DRP ADVICE 10.1

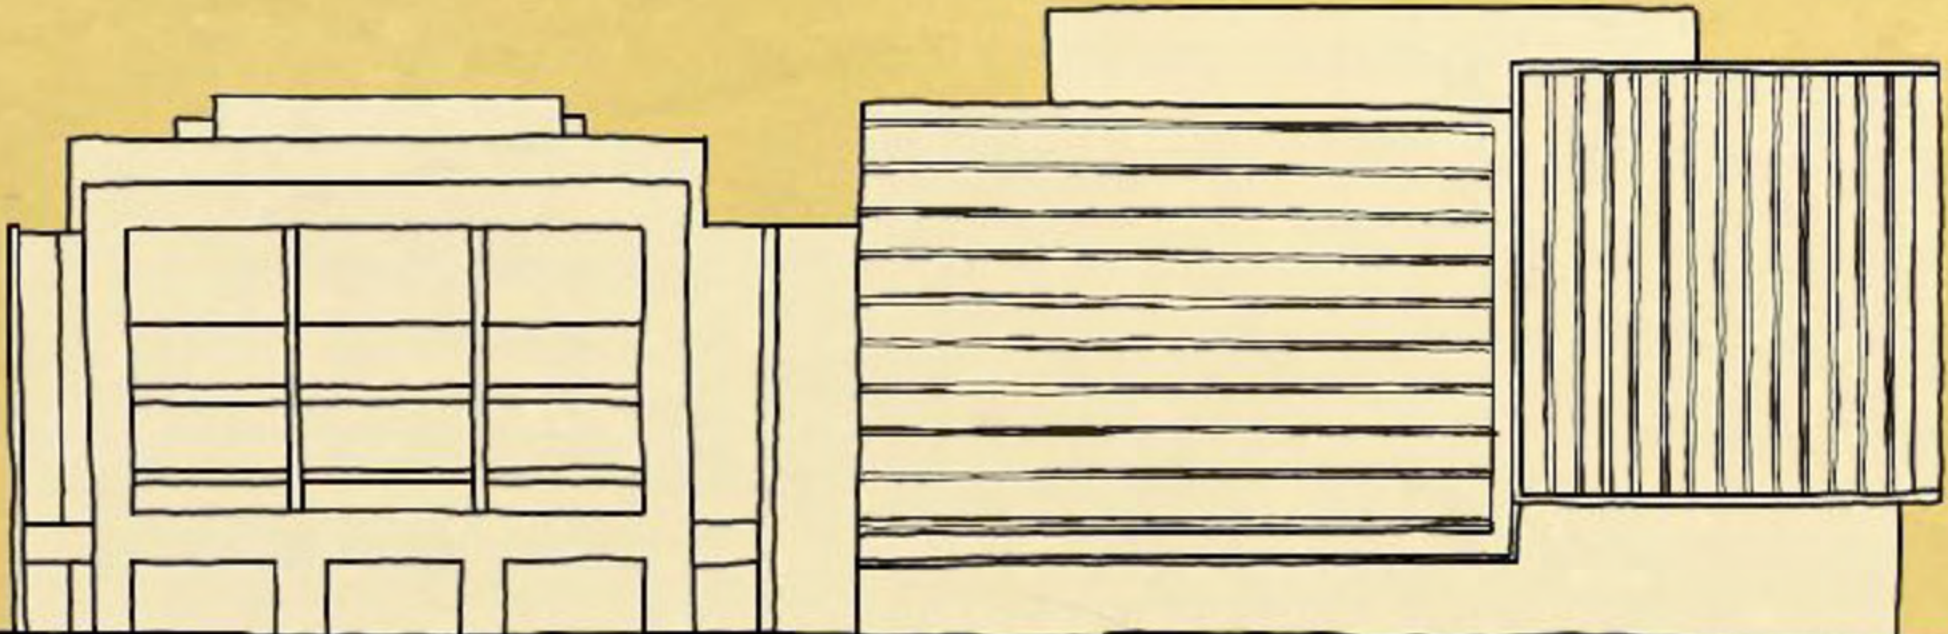
The Panel notes that the materiality of the proposal was not discussed in detail at the design review session however, the Panel considered the current extensive glazed façade presented to be incongruous with the setting of a proposed development within the National Triangle. Given the early design phase of the proposal, the Panel encourages the proponent team to develop a strong vision for the proposal which is 'of place' and consider implementing a materiality and architectural expression appropriate to the residential use as well as the civic nature and setting of the development.
